2 SITE CHARACTERISTICS

2.0 North Anna 3 Site

This chapter of the U.S. Nuclear Regulatory Commission's (NRC's) safety evaluation report (SER) provides the NRC staff evaluation of the North Anna 3 Combined License (COL) Final Safety Analysis Report (FSAR) which addresses the geological, seismological, hydrological, and meteorological characteristics of the site and vicinity, in conjunction with present and projected population distributions and land use and site activities and controls.

Figure 2.4.2-2. Site map with locations of the in-line control structures that correspond to blocked culverts (after North Anna 3 COL FSAR Figure 2.4-203)

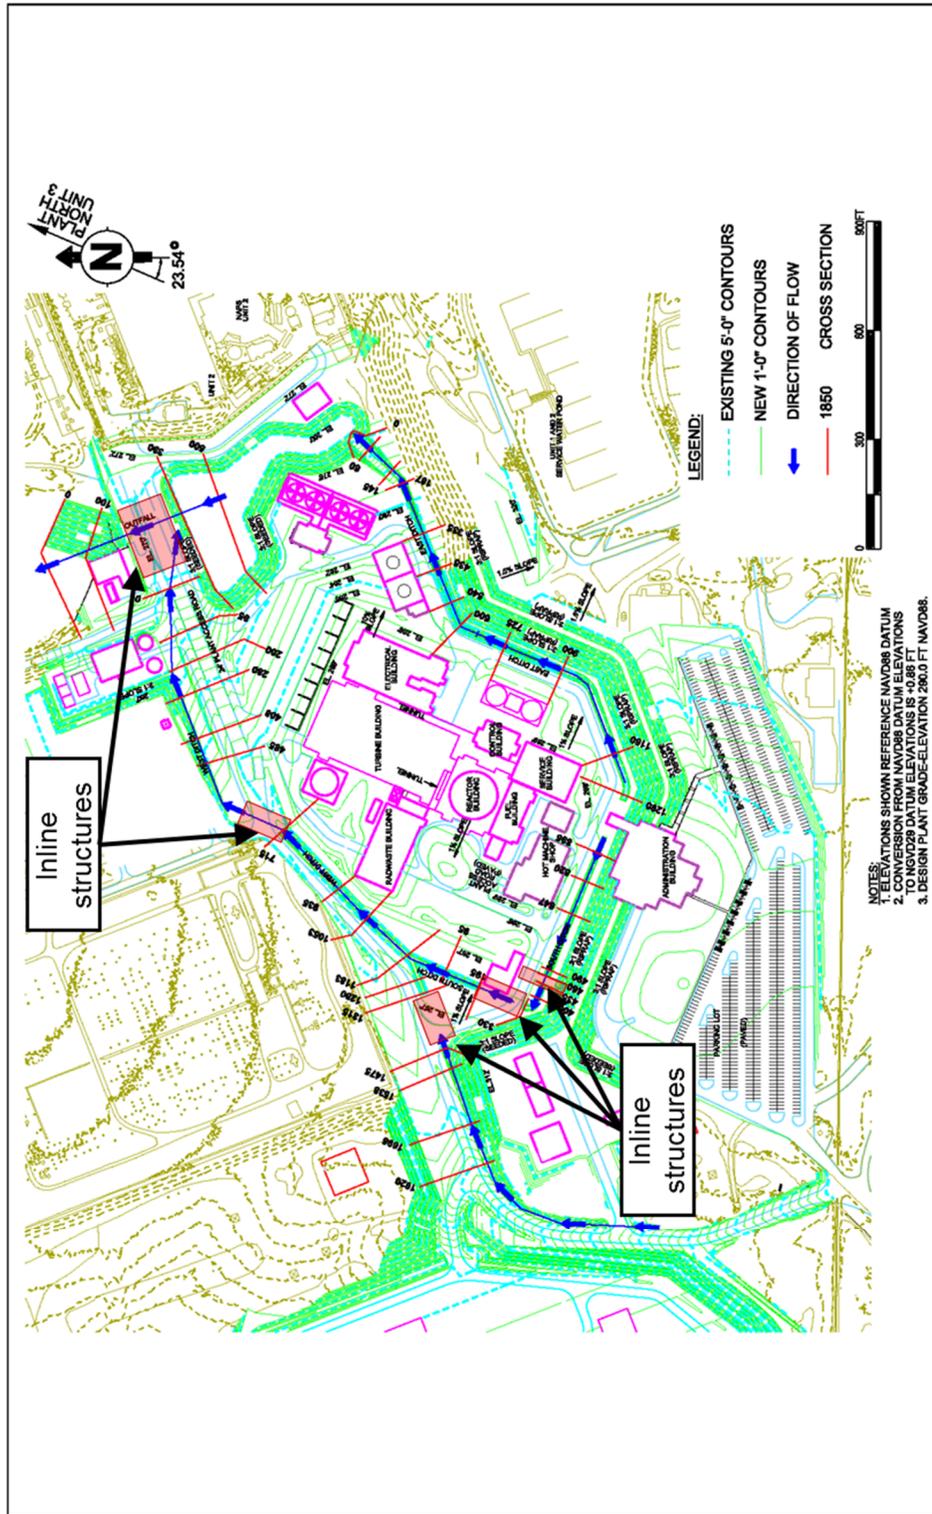
The COL applicant assumed that the roads crossing the west and south ditches and the outfall from the stormwater management pond were completely blocked and functioned as weirs during the flooding from local intense precipitation (Figures 2.4.2-1 and 2.4.2-2). As found in the COL applicant's HEC-RAS input files, inline weirs were designated as broad-crested weirs with discharge coefficients specified as either 2.6 or 2.4. Because the COL applicant did not provide a justification for choosing the lower of these two discharge coefficient values, in RAI 02.04.02-14, the staff requested that the COL applicant provide a discussion of the basis for selecting weir discharge coefficients. The COL applicant's response dated January 19, 2015 (ADAMS Accession No. ML15022A199), and the staff's evaluation are described in the staff's technical evaluation section below in this SER.

The staff noted that the applicant's HEC-RAS input file geometry was inconsistent with the connectivity of the west ditch for the storm water management pond. In RAI 02.04.02-12, the staff requested that the COL applicant explain the apparent disagreement between the HEC-RAS input files and North Anna 3 COL FSAR Figures 2.4.201 and 2.4.203 which illustrate the connection of the west ditch to the stormwater management pond. In response to RAI 02.04.02-12 (ADAMS Accession No. ML15022A199), the COL applicant stated that as the west ditch approaches the stormwater management pond, water will flow in three directions: a portion will flow north into an area adjacent to the intake channel, another portion will flow south into the stormwater management pond, and a third portion will continue flowing along the west ditch towards the stormwater management pond outlet and into Lake Anna. The COL applicant chose to direct all flow from the west ditch into the stormwater management pond because the calculated water surface elevation would then be conservatively higher in Subbasin B. The COL applicant proposed updating North Anna 3 COL FSAR Figures 2.4-201 and 2.4-203 to correctly depict the discharge from the west ditch into the stormwater management pond, consistent with the HEC-RAS model setup. The staff determined that the COL applicant's response was adequate and verified that the appropriate updates to Figures 2.4-201 and 2.4-203 are incorporated into the FSAR, Revision 9, and, therefore, Confirmatory Item 2.4.2-3 from the staff's advanced SER for North Anna 3 is resolved and closed.

Figure 2.4.2-3. Site map with locations of supercritical flow and of hydraulic jumps from the applicant's HEC-RAS model and North Anna 3 COL FSAR Figure 2.4-221 (after North Anna 3 COL FSAR Figure 2.4-203)

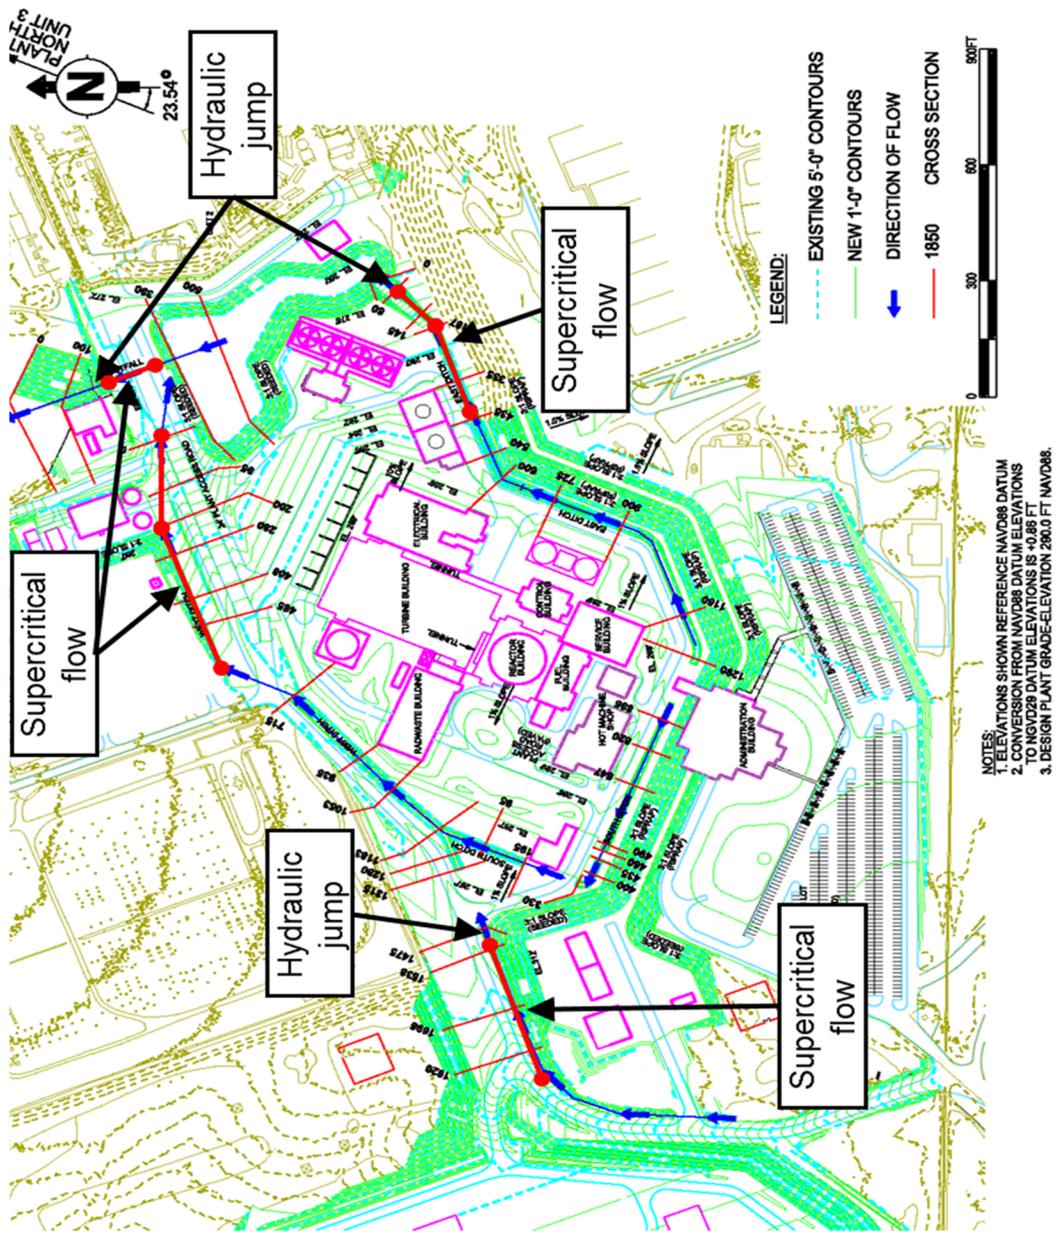
Based on the staff's examination of the COL applicant's HEC-RAS analysis results, supercritical flow was found to occur in the east and west ditches during flooding from local intense precipitation. In these locations, the water velocities ranged from 2.1 m/s (7.0 fps) to 4.5 m/s (14.7 fps) with Figure 2.4.2-3 showing the locations of supercritical flow based on the HEC-RAS analysis. In North Anna 3 COL FSAR Section 2.4.2.3, the COL applicant stated that:

- The locations where supercritical flow regimes were predicted to occur would be protected against possible erosive forces arising from large velocities and potential hydraulic jumps using linings and hardened surface protections;

Figure 2.4.122-1. NAPS Unit 3 groundwater head observations on 5/30/2007 as a function of ground surface elevation at the well

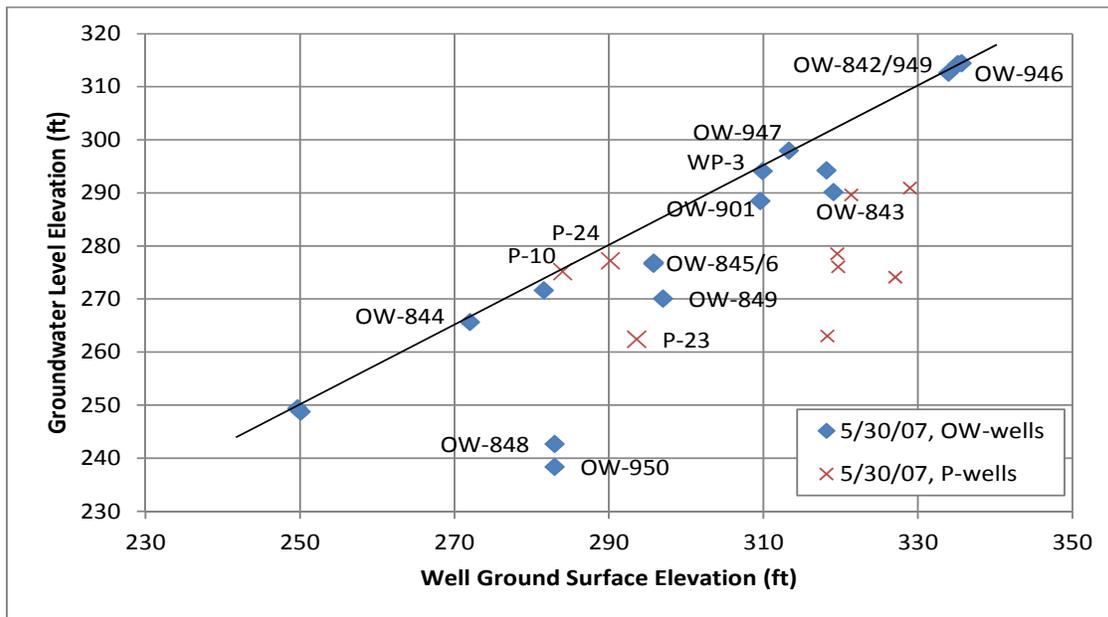
While no observations fall significantly above the envelope line in Figure 2.4.12-1, a number of observations fall significantly below the line. The staff examined the current site topography, as shown on FSAR Figure 2.4-206, and determined that the wells with observations below the line in Figure 2.4.12-1 tended to be located above and near a significant topographic slope. For example, OW-848 and OW-950 are on the bluff above the proposed North Anna 3 intake bay, and OW-849 and OW-843 are above the cut-slope for the switch yard. In contrast, the observations that lie close to the line in Figure 2.4.12-1 tended to be in areas of relatively flat topography, or near the bottom of topographic slopes. For example, OW-844 lies just below the cut-slope down to the Unit 1/2 operations level.

The COL applicant's pre-construction model, calibrated using the May 30, 2007 groundwater observations, resulted in groundwater heads at several observation wells that were above the envelope line shown in Figure 2.4.12-1. The greatest deviations were at wells OW-945, a relatively low-lying area where the model produced flooded conditions, and OW-844, located at the bottom of a cut-slope. The deviation at OW-844 was about 1.22 m (4 ft). Based on the observations shown in Figure 2.4.12-1, the staff concluded that groundwater head measured in a well located at a surface elevation of 88.39 m (290 ft) (the North Anna 3 design plant grade) would be unlikely to exceed 85.34 m (280 ft). The COL applicant's post-construction model predicted heads about 1.22 m (4 ft) greater than this in the power block area: 86.53 m (283.9 ft) at the Ancillary Diesel Building, located near the cut-slope down to the power block. The staff concluded that the COL applicant's groundwater model will tend to over-estimate groundwater heads below a cut-slope such as that planned around the North Anna 3 power block area.

Figure 2.5.1-5. LiDAR-Derived Relief Map of the 2011 Mineral, VA, Earthquake Vicinity (from FSAR Figure 2.5.1-212A, Rev 9). Relief is represented as elevation difference within 0.5 km. The margin of Ellisville Biotite Granodiorite based on Burton et al. (2014) and Dicken et al. (2005)

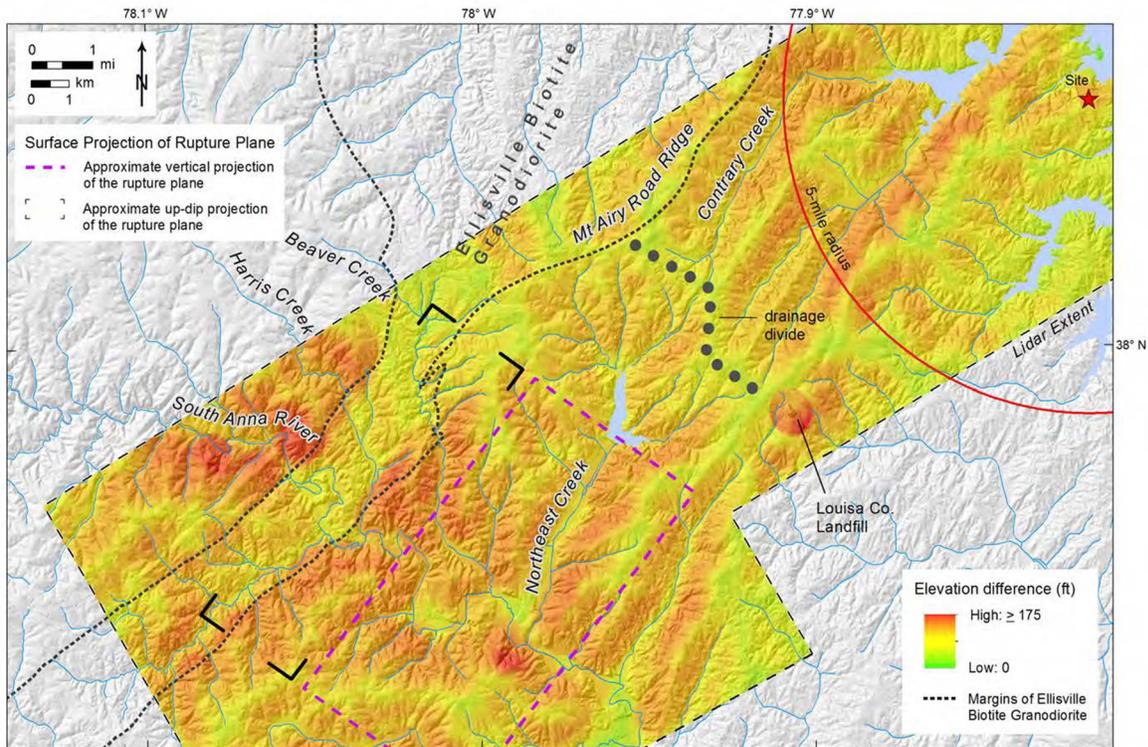
In supplemental RAI 02.05.01-8 dated August 1, 2014 (ADAMS Accession No. ML14283A557), the staff also asked the COL applicant for additional information regarding the tectonic significance high relief values concentrated in the up-dip projection of the Quail fault and the epicentral area in general as illustrated in Figure 6 of previous response to RAI 02.05.01-4, Part B.

In response, the COL applicant provided new map figures to provide a basis for their analysis regarding surface deformation related to the Mineral earthquake. Figure 2.5.1-5 shows a newly derived relief map using a linear color ramp to symbolize the local relief value across the epicentral area and to the NE, closer to North Anna 3. The staff notes that, in the area around the Ellisville pluton neck, high to low relief boundaries closely correspond to geologic map unit contacts. This supports the COL applicant's suggestion that the steep relief gradients are related to lithologic difference between map units rather than subtle tectonic uplift related to shallow earthquakes. The Chopawamsic Formation, to the NW and SE of the Ellisville pluton neck, is more erosion resistant than the Ellisville and, therefore, supports higher elevation and higher relief zones. In addition, staff notes, that the South Anna river system crosses the same geologic contacts by the Ellisville neck and the Mineral earthquake epicentral area. The river is a significant erosional agent in the area and lowers elevations in its basin but also contributes to the development of high local relief within its basin (Compare Figures 2.5.1-5 and 2.5.1-6). The staff also notes that high relief values diminish to the NE, near the basin divide between the South Anna and the North Anna river systems. The most continuous areas of low relief can be found along prominent drainage divides and areas of higher elevation, which represent areas farthest removed from the increased erosion rates associated with trunk streams. The staff

Figure 2.5.1-4. NAPS Geologic Field Reconnaissance after the 2011 Mineral, VA, earthquake showing traverse routes, waypoints and the LiDAR survey boundary (from FSAR Figure 2.5.1-204, Rev. 9)

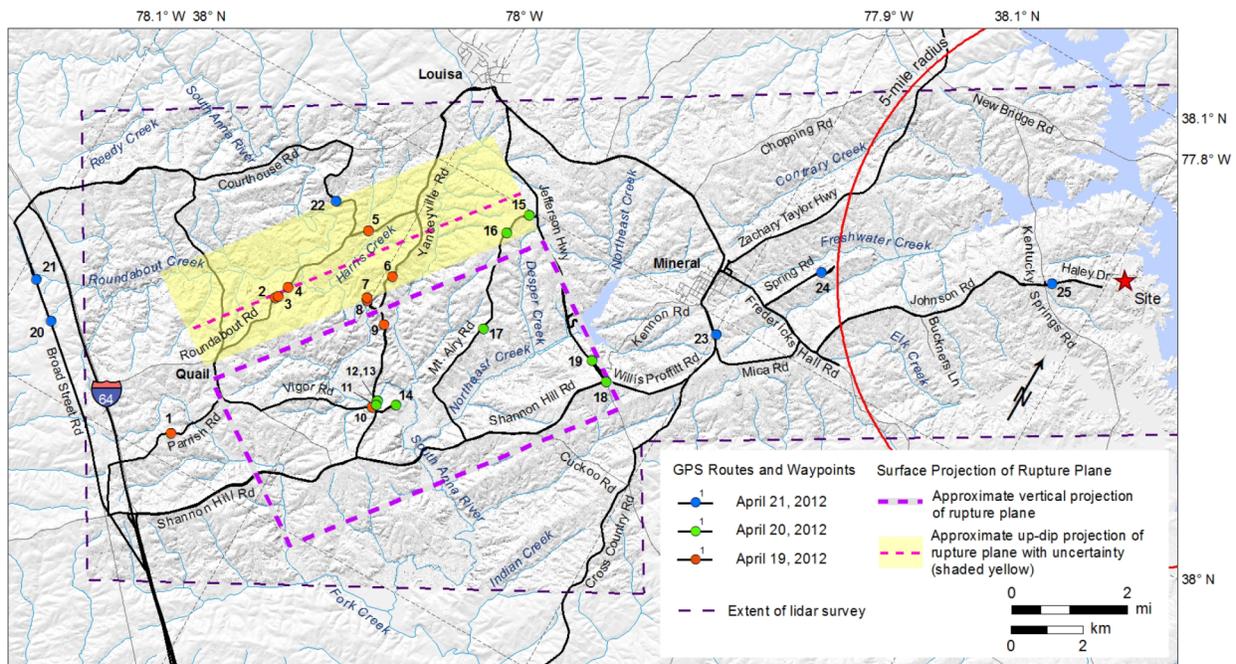
- a) At each waypoint, what was examined and what is its significance.
- b) Provide a high resolution LiDAR map (scale ~1:10,000) for areas immediately west of North Anna 3 where fault 'a' might be located, such as waypoint sites 23, 24, and 25.
- c) Discuss longitudinal stream profile analysis completed in the epicentral area. Discuss any anomalies revealed by this analysis that could indicate subtle tectonic deformation in the hanging wall of the Quail fault, such as gradient changes, offset stream terraces, elevated topography.
- d) Explain how you evaluated the Quaternary geology of the epicentral area and the distribution, correlation and elevation of river terraces on the South Anna River. Discuss any indication of subtle surface uplift in river terraces on the hanging wall of Quail fault that might indicate prolonged or repeated surface deformation.

In a June 10, 2014, response to RAI 02.05.01-5a and b (ADAMS Accession No. ML14177A441), the COL applicant provided a table with details for the significance of each waypoint visited during the field reconnaissance program. Observations at some of the waypoints confirm

Figure 2.5.2-7. Map of Changes in Seismicity Rates and B-Values for CEUS-SSC Source Zone ECC-AM, Case A (Figure from Applicant Response to RAI 2.5.2-7.)

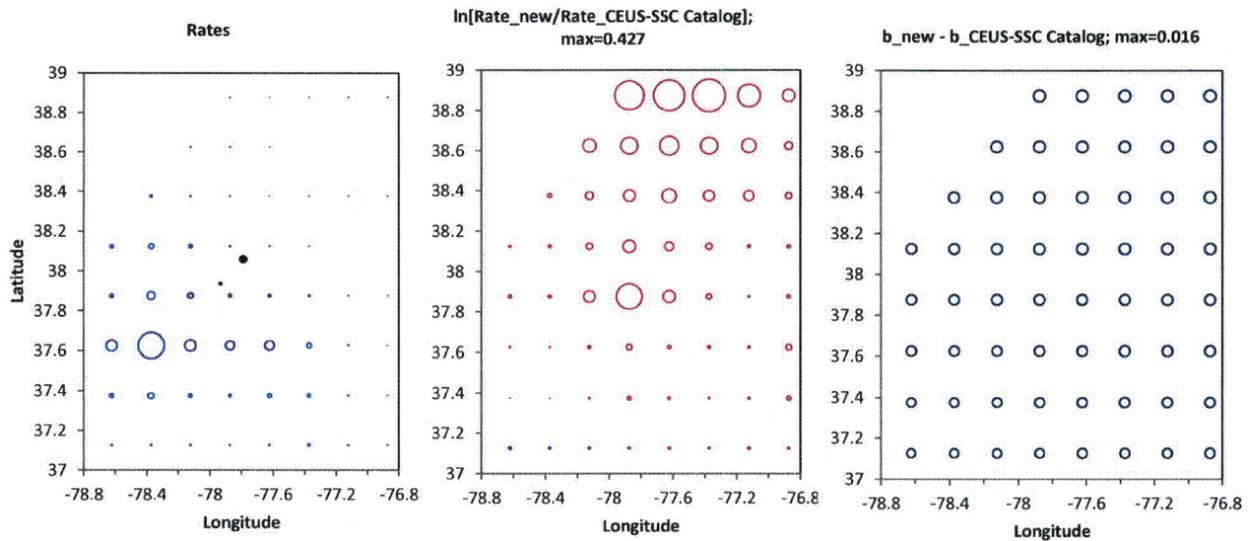
On August 23, 2011, the **M5.8** Mineral earthquake occurred approximately 23 km (14 mi) from the North Anna 3 site. The occurrence of a moderate magnitude earthquake within the site vicinity indicates that a previously unrecognized seismic source may exist that poses a hazard at the plant. This new and significant information led the staff to reopen the PSHA previously evaluated as part of the ESP. In RAI 2.5.2-4, dated November 1, 2011 (ADAMS Accession No. ML11305A261), the staff asked the applicant to assess the adequacy of the EPRI SOG (EPRI, 1986, 1989) seismic source model in light of the Mineral, Virginia earthquake. In RAI 2.5.2-8 dated July 8, 2015 (ADAMS Accession No. ML15233A433), the staff also asked the applicant to address any exceedances of the postulated GMRS by observed ground motions at the existing North Anna 1 in terms of the adequacy of the seismic design parameters in FSAR Section 3.7.1 to account for the recordings. The RAI also asked the applicant to specify the operability criteria for the as-found conditions of safety-related SSCs, until the SSC is restored to meet the original design basis and design criteria, to ensure that such demonstrations would consider the Mineral, Virginia earthquake recordings. In the response to RAI 2.5.2-4 dated February 13, 2012 (ADAMS Accession No. ML12048A096), the applicant responded that the record of the **M5.8** Mineral earthquake is considered in development of the North Anna 3 SSE by including a comparison with the CSDRS. The applicant demonstrated that the Unit 1 containment mat earthquake recorded motion in all three directions are enveloped by the North Anna 3 CSDRS at all frequencies. Further, the applicant clarified the FSAR description of the seismic design parameters in FSAR Section 3.7.1 by noting that these site-specific recorded motions for North Anna are enveloped by the CSDRS, which is the licensing basis for all Category I structures. Regarding operability, the applicant included a criteria in Section 3.7.1 of the FSAR that the SSE design ground motion will be used in operability assessments to demonstrate plant safety for the as-found conditions of safety-related SSCs. Since the SSE design ground motion includes both the CSDRS and the site-specific FIRS, and the CSDRS envelopes these recordings and is the licensing basis for all Category I structures and would be used in determining operability or other demonstrations of plant safety, the staff considers RAI 2.5.2-8 resolved and closed. The staff verified that the appropriate change is incorporated in the FSAR, Revision 9, and, therefore, Confirmatory Item 2.5.2.01 from the staff's advanced SER for North Anna 3 is resolved and closed.

In the response to RAI 2.5.2-7 dated May 9, 2014 (ADAMS Accession No. ML14140A087), and supplemented on May 29, 2014 (ADAMS Accession No. ML14150A439), the applicant provided detailed information about how the updated seismicity catalog influenced rates and b-values in the CEUS-SSC and provided the requested comparison of hazard. The applicant provided plots (example shown on Figure 2.5.2-7 of this SER) of updated rates and b-values for the four distributed seismicity zones that the North Anna 3 site lays within (ECC-AM, MESE-N, MESE-W, and STUDY-R). Further In its response to RAI 2.5.2-7, the applicant provided a Table-1 and a Figure-13, comparing the updated and the baseline seismic hazard at a variety of input spectral acceleration levels. The applicant demonstrated that the updated seismic catalog increases hazard at the North Anna 3 site up to 9 percent for annual frequencies of exceedance lower than 10^{-4} .

Figure 2.5.2-8. Comparison of the Applicant's Base Rock Hazard Curves with the Results of the Staff's Confirmatory Analysis

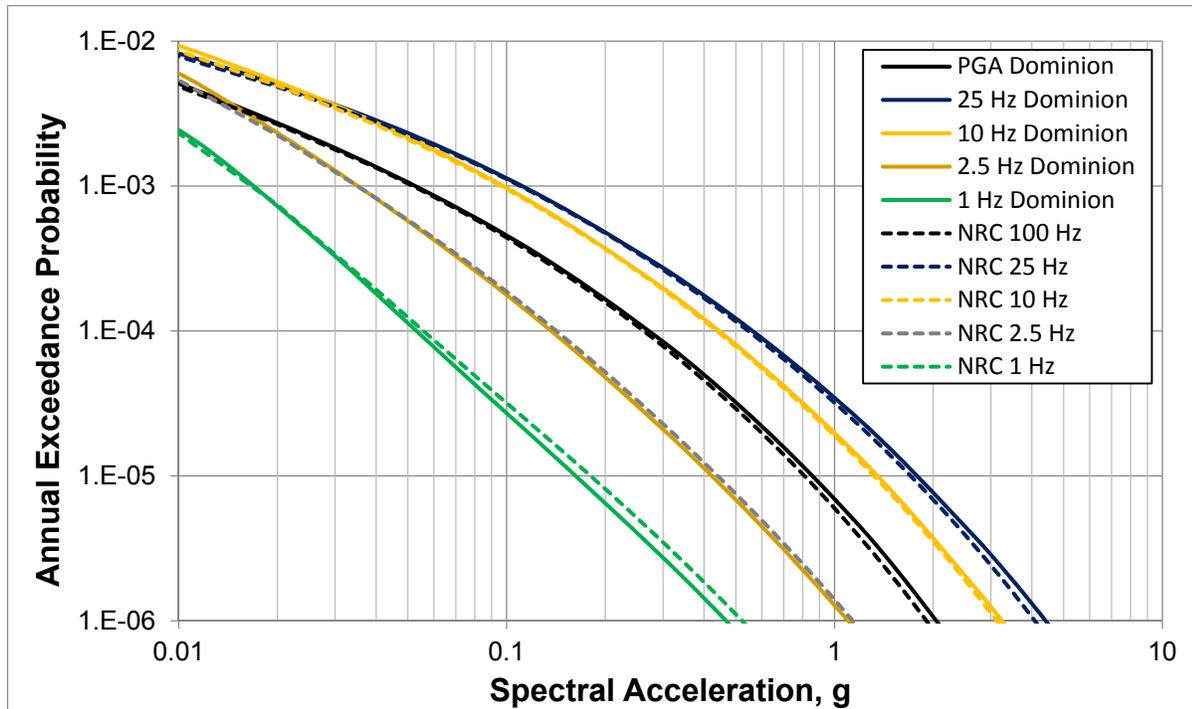
The staff also conducted an independent confirmatory analysis of the PSHA. The staff calculated the hazard at the North Anna 3 site using the published CEUS-SSC for distances up to 500 km (310 mi) for distributed seismicity sources and 1,000 km (620 mi) for RLME sources. In its confirmatory analysis, staff used the EPRI (2013) GMM. Figure 2.5.2-8 of this SER compares the PSHA results from the staff's independent confirmatory analysis with those of the applicant for PGA and frequencies of 25, 10, 2.5, and 1 Hz. The staff's and the applicant's calculations are in acceptable agreement. The staff used its independent PSHA results to develop site specific UHRS at the 10^{-4} and 10^{-5} exceedance frequencies. SER Figure 2.5.2-9 compares 10^{-4} and 10^{-5} UHRS developed by the staff with those developed by the applicant. Because the UHRS results developed by the staff are in acceptable agreement with those developed by the applicant and the applicant has incorporated seismicity after the publication of the CEUS-SSC, including the Mineral earthquake, the staff finds the applicant's PSHA acceptable.

Based on the applicant's response, the results of staff's site audit and its independent confirmatory analysis, staff considers RAI 2.5.2-7 resolved and closed.
